| Project Title: | Fountain Wind Project |
| Document Title: | fwp_project_description_2024_update_redline |

Reference: Fountain Wind Project Updated Project Description

Project Description

Figure 5 Typical Overhead Collector Line Pole

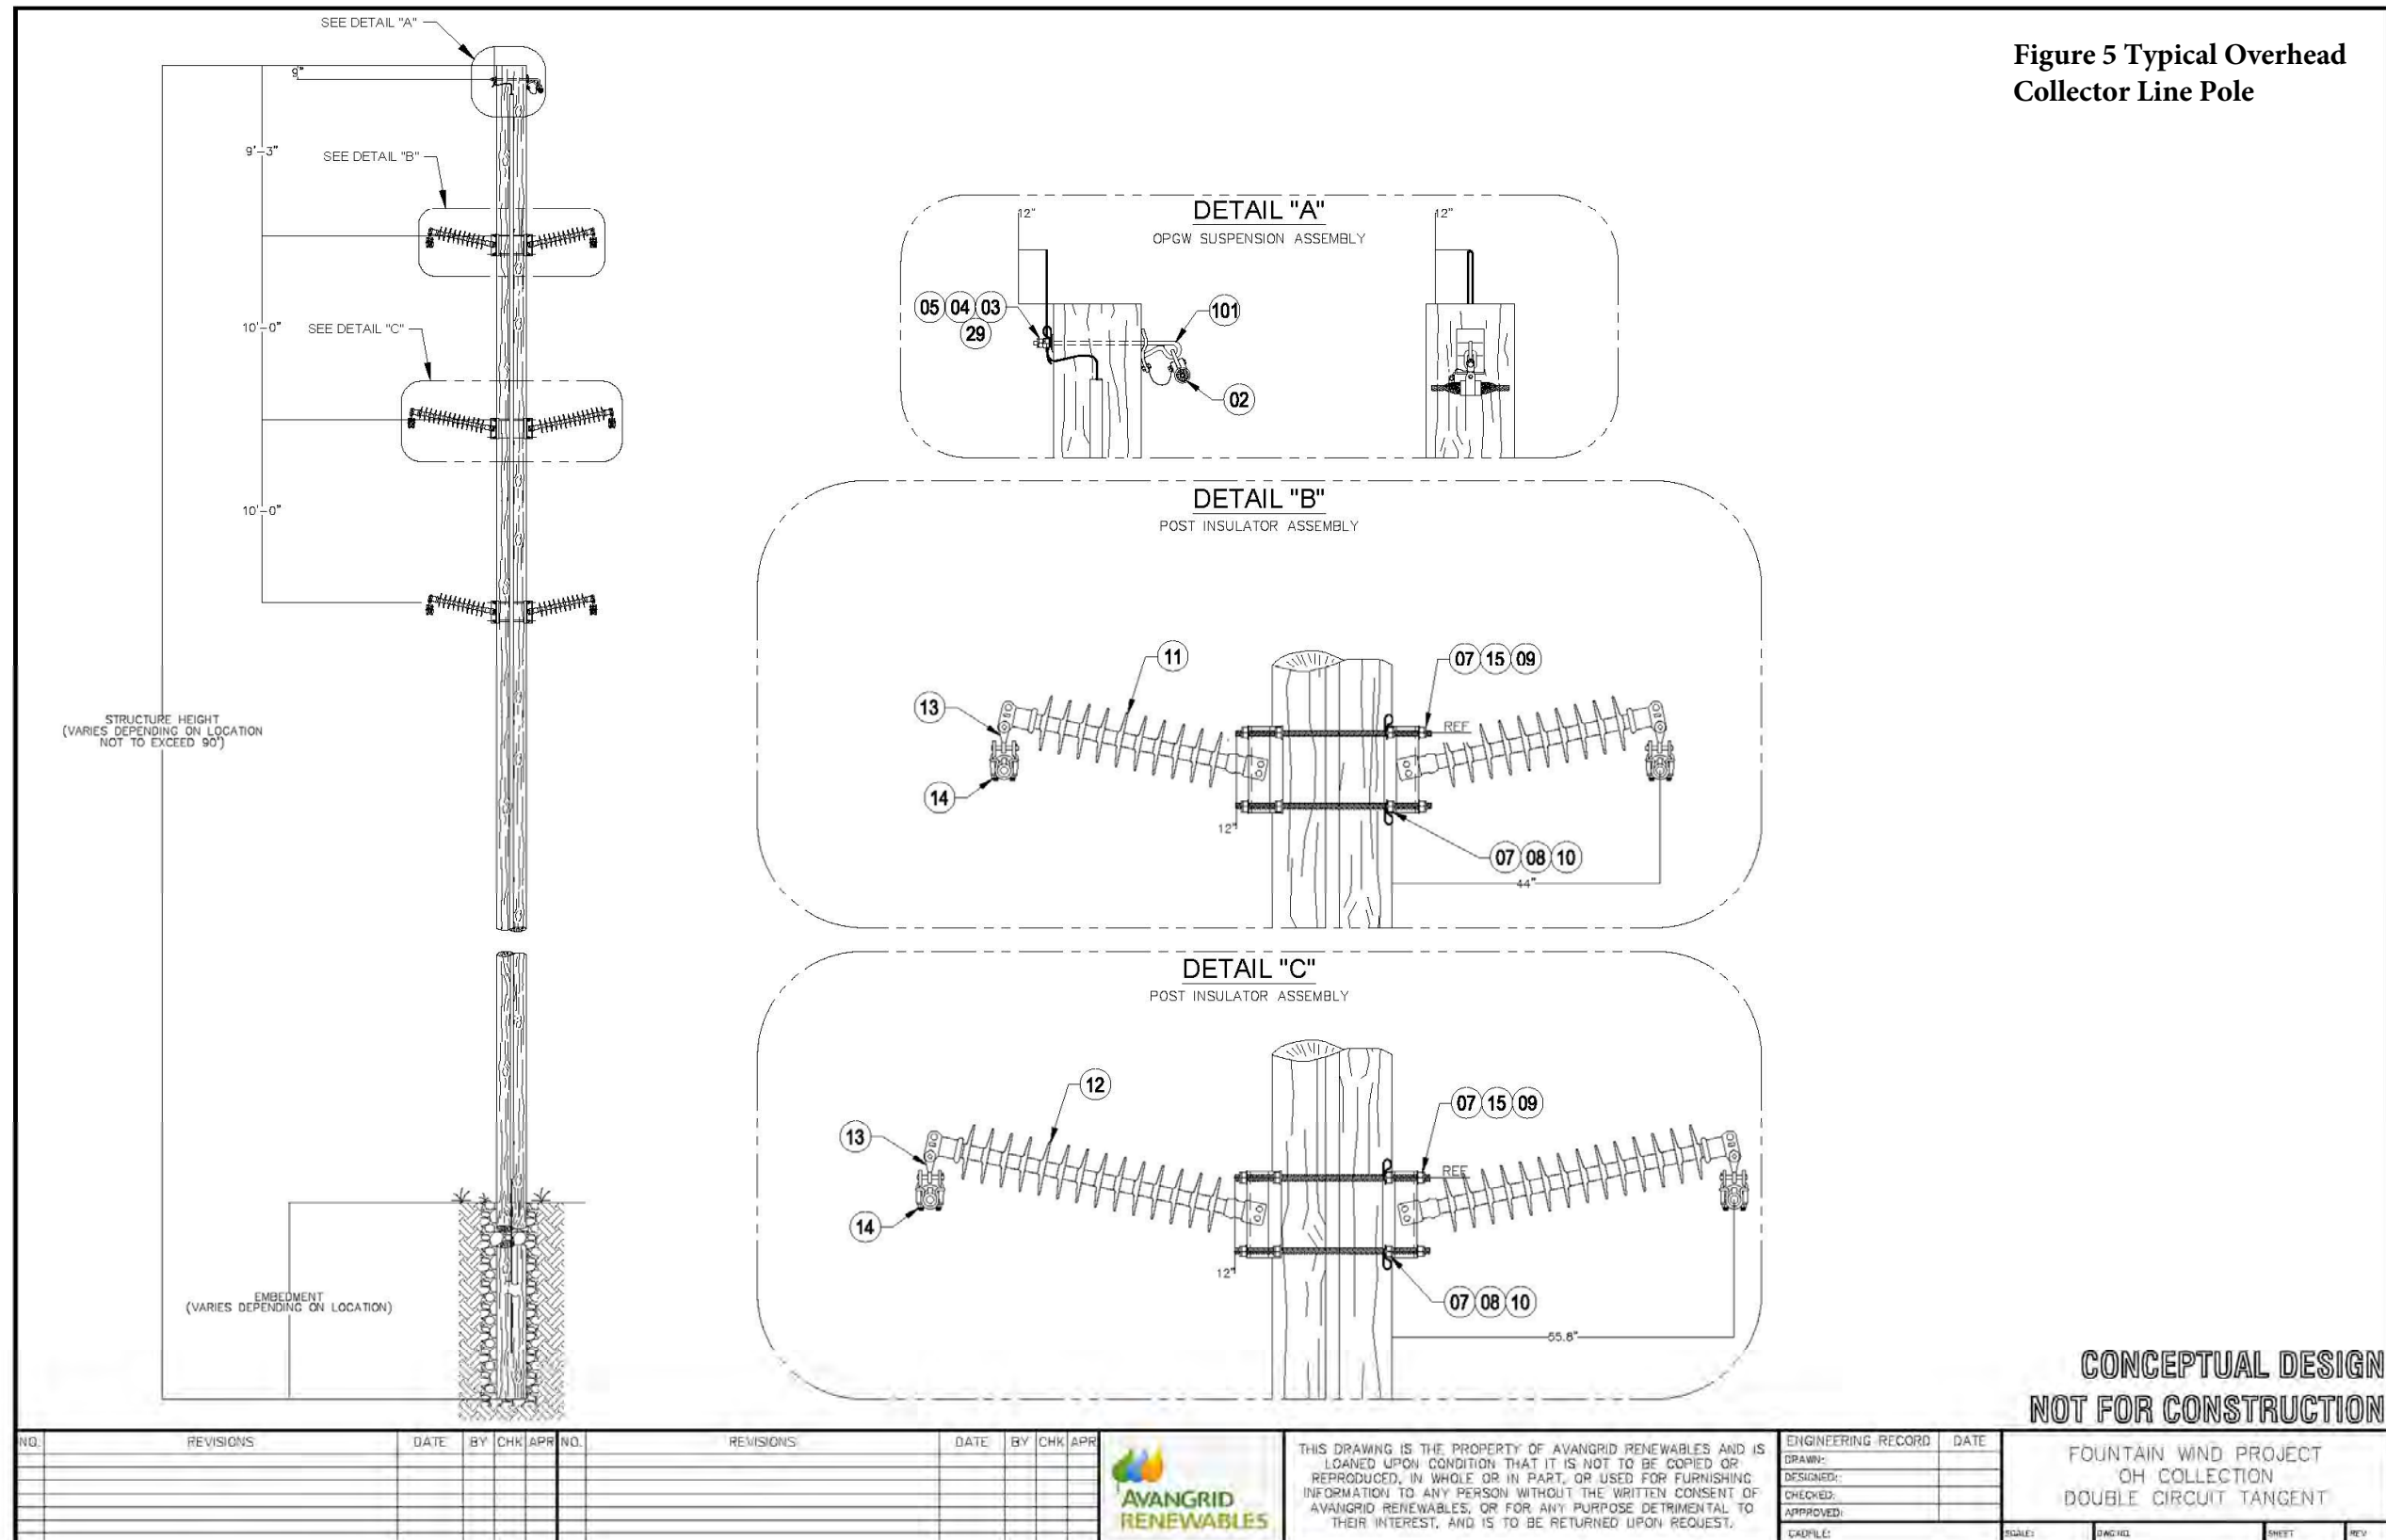
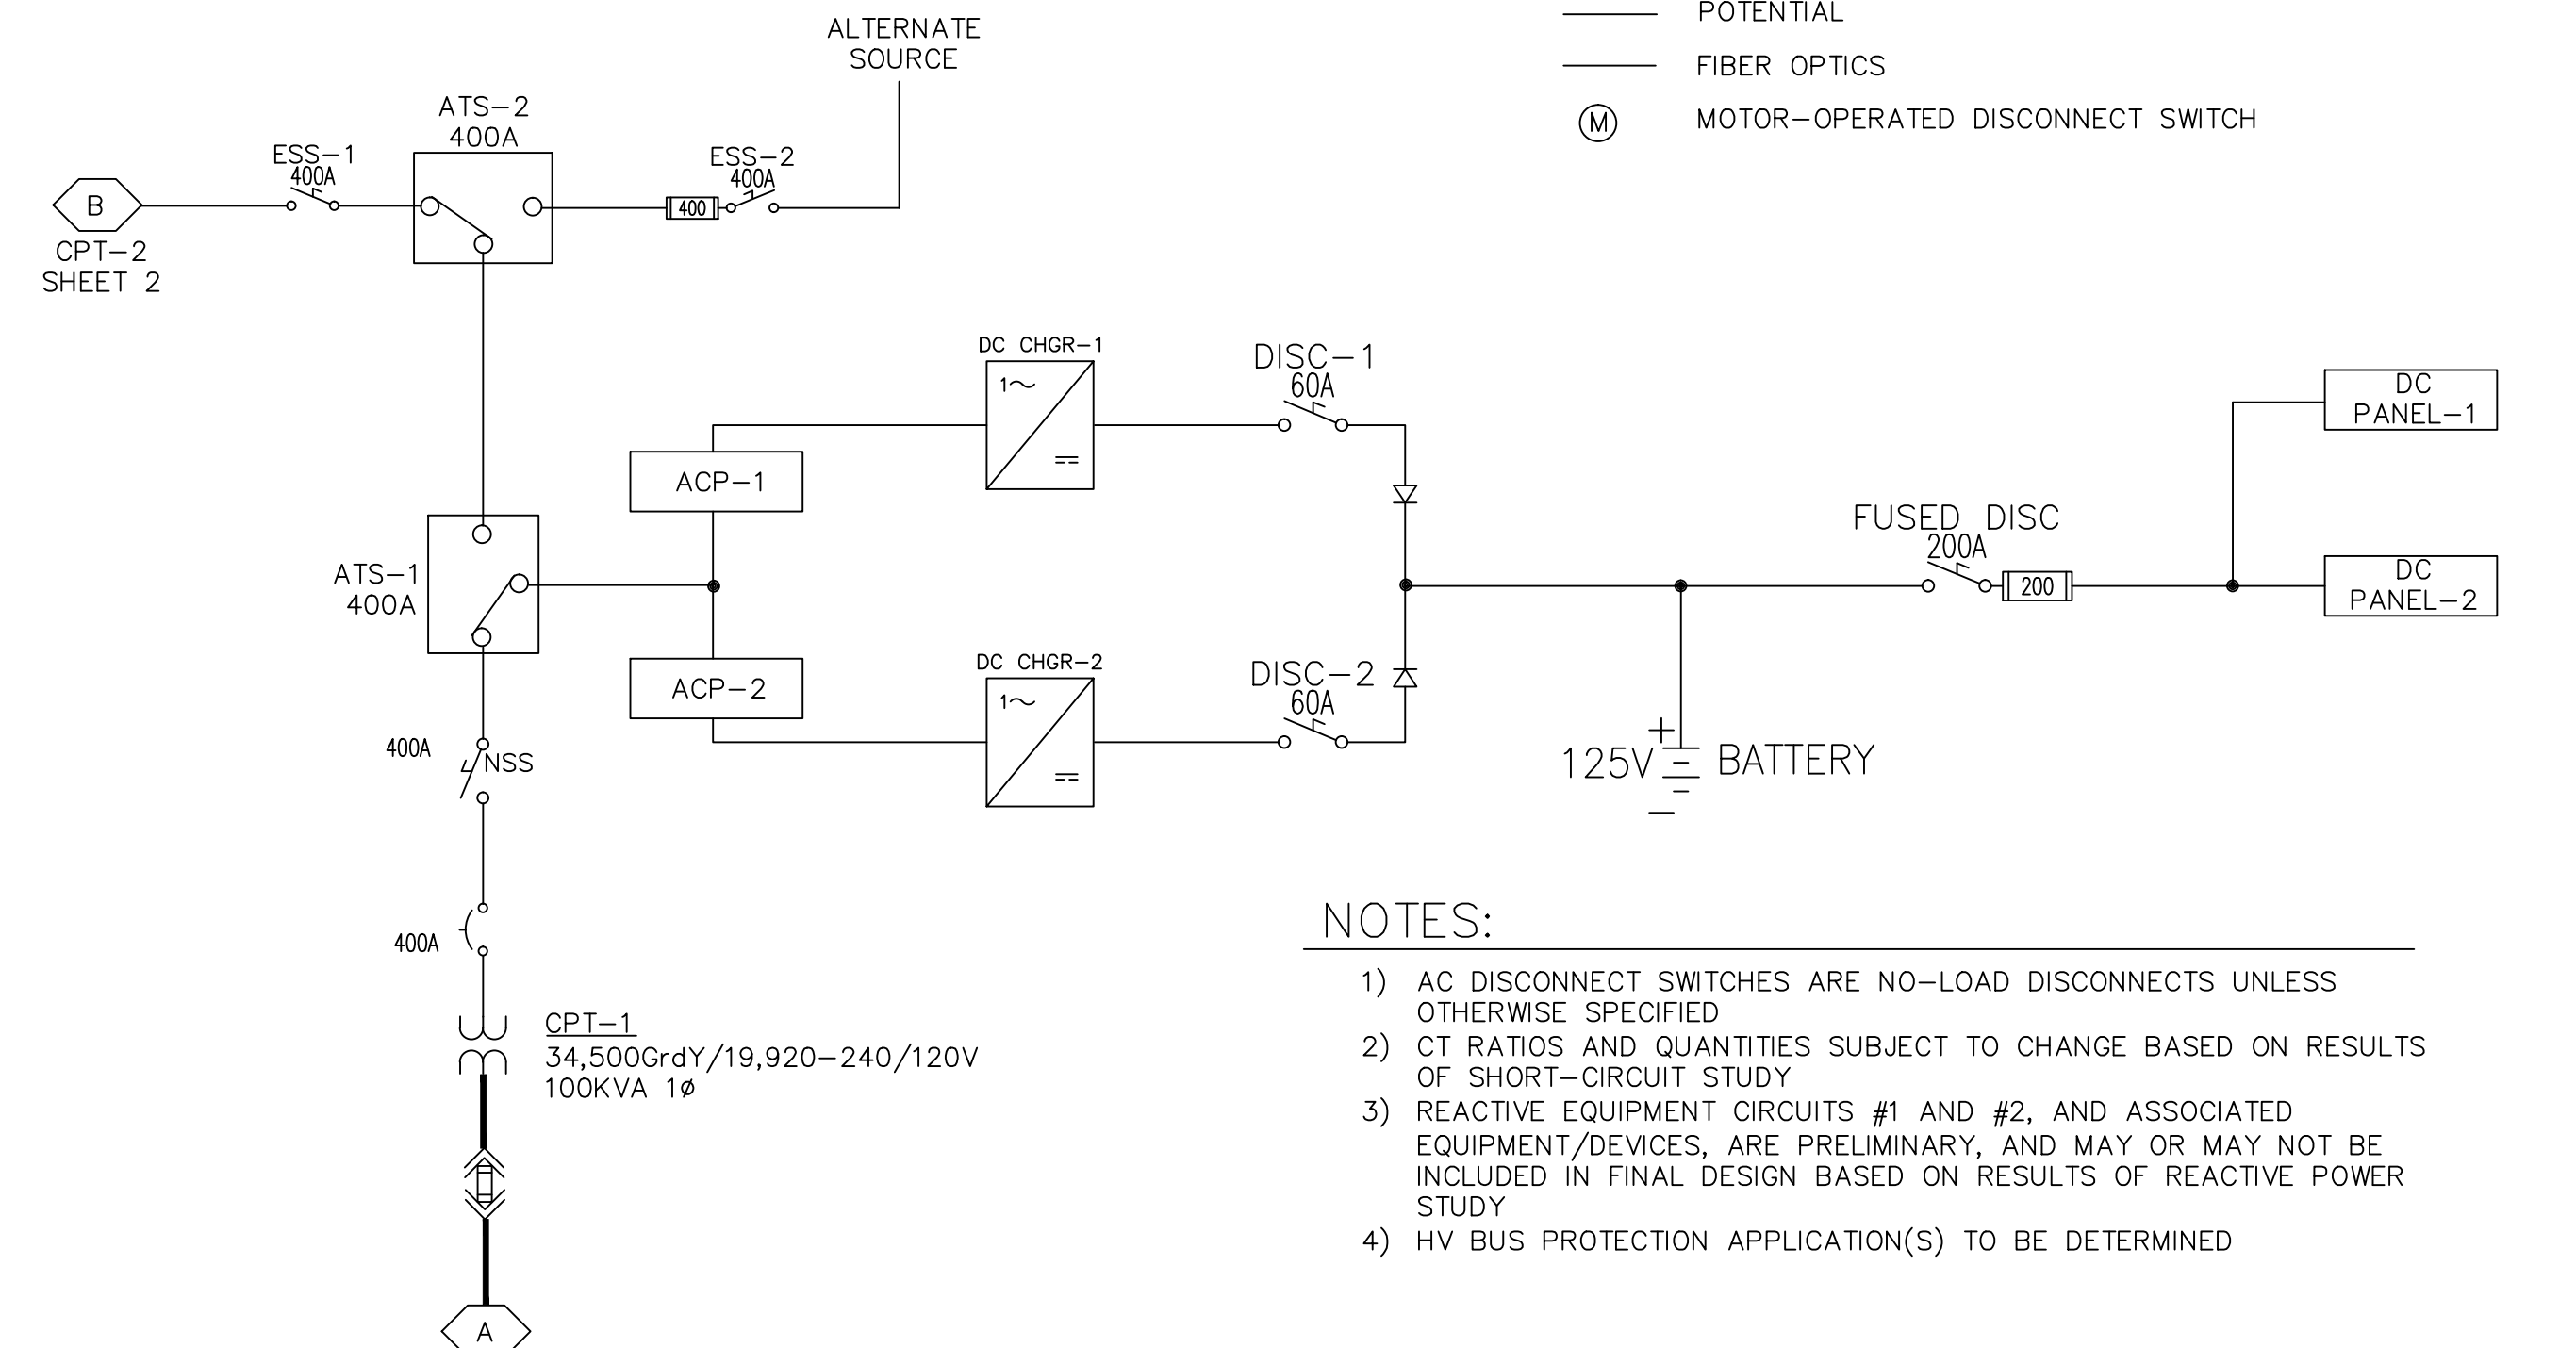
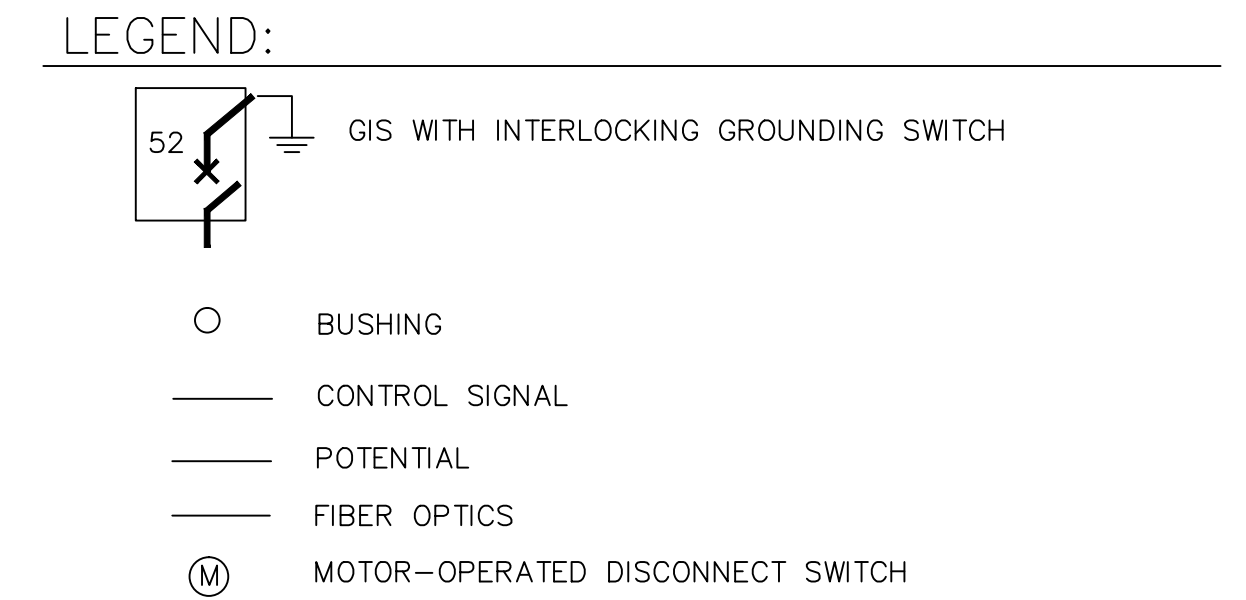
See also Figure 5, which shows conceptual design details of the proposed overhead collector system poles.

The 34.5 kV overhead electrical collector system would be installed on wood poles with a maximum height of 90 feet and wire heights between approximately 20 to 30 feet above the ground depending on the span (Figure 5); however, special circumstances could require greater wire clearances. Installation of the overhead collector line could require a temporary workspace consisting of an approximately 100-foot-wide corridor centered on the
